From: "APNNL NRC Vogtle" <nrc.vogtle@pnl.gov>
To: <VOGTLE_EIS@nrc.gov>
Date: 5/7/2007 3:14:09 PM
Subject: FW: Part 2 - NRC Submittal

From: Williams, Dana M. [mailto:X2DANAWI@southernco.com]
Sent: Monday, December 11, 2006 3:16 PM
To: cja2@nrc.gov; mdn@nrc.gov; Sackschewsky, Michael R
Cc: Moorer, Tom C.
Subject: Part 2 - NRC Submittal

AR-06-2684

NRC Question 114

Figure 1 – Average daily suspended sediment load for Savannah River at Clio, GA (USGS Gage No. 2198500)

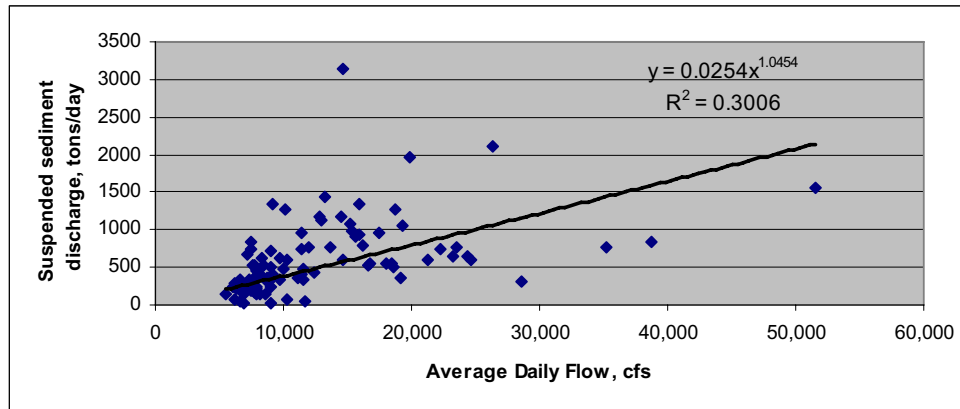
Provide estimated erosion characteristics and sediment transport rates, including bed and suspended load fractions, for the Savannah River near the site.

These data points are listed in Table 2 and are plotted in Figure 1 against the average daily discharge recorded for those days. There is only a slight correlation between average daily discharge in cfs and suspended sediment load in tons per day, so the suspended load data time series can not be extended with much reliability.
